Metro South-West Joint Development Assessment Panel Agenda

Meeting Date and Time: 9 December 2019; 10am
Meeting Number: MSWJDAP/196
Meeting Venue: City of Rockingham
Civic Boulevard
Rockingham

Property Location:	Lots 726 (591) and 107 (577) Eighty Road, Baldivis
Development Description:	Child Care Premises
Applicant:	Planning Solutions
Owner:	Mr George & Mrs Margaret Yiannakis, Mr Blair Thomas
Responsible Authority:	City of Rockingham
DAP File No:	DAP/19/01660

Figure 10 - Fence plans

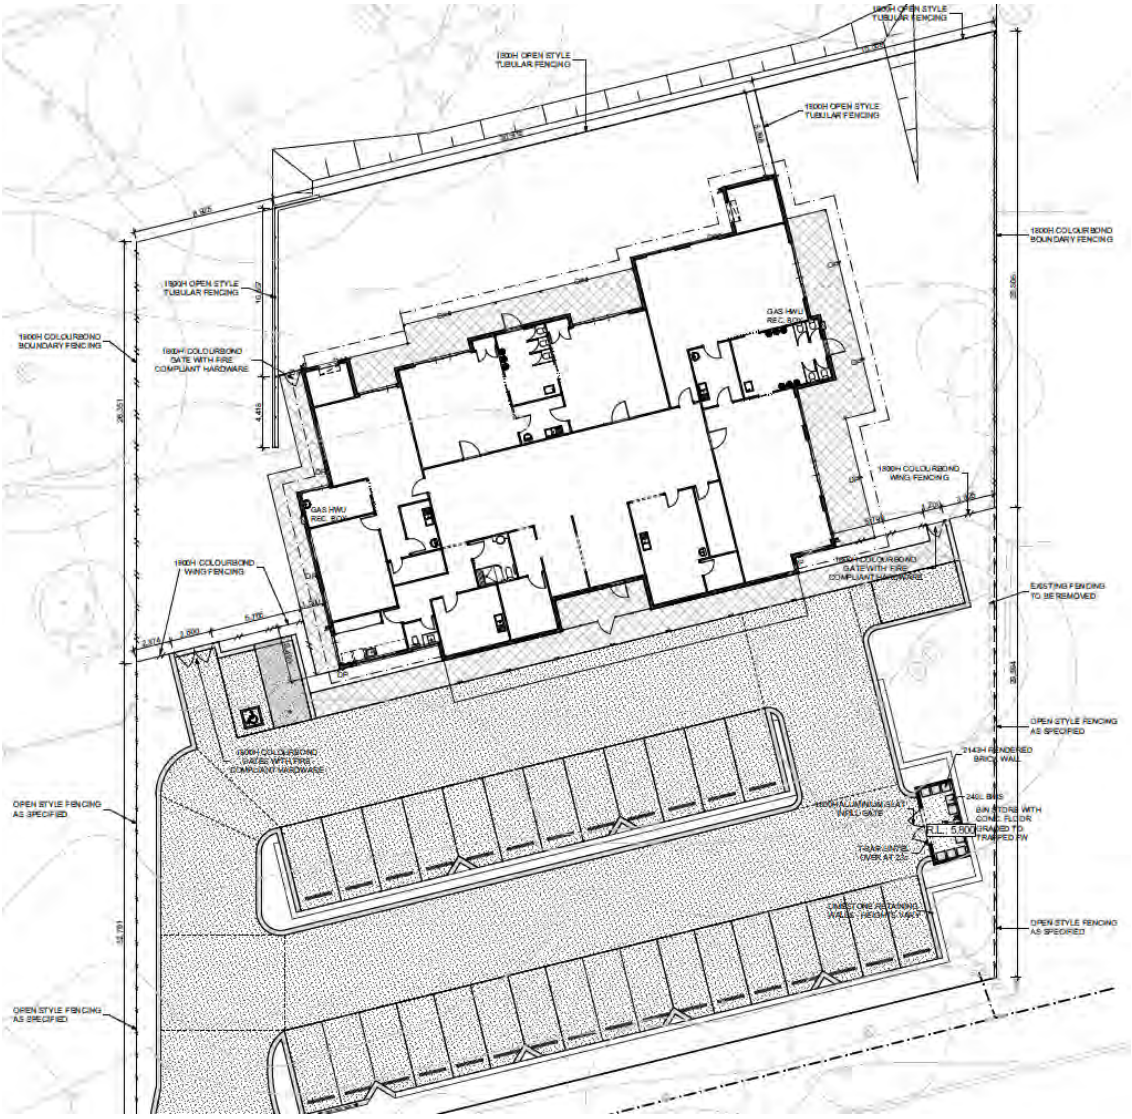
Schedule 3 of the Local Law applies to this development proposal as it sets out specifications for a 'sufficient fence' on a rural lot. The proposed fencing is non-compliant with Schedule 3 which requires 'rural style' iron star picket or timber post fencing at a maximum height of 1.2m above ground level or stainer post fencing.

Should MSWJDAP resolve to approve this development, it is recommended all link fencing within the setback area be modified to comply with Schedule 3 of the Local Law for 1.2m high post or strainer post fencing.
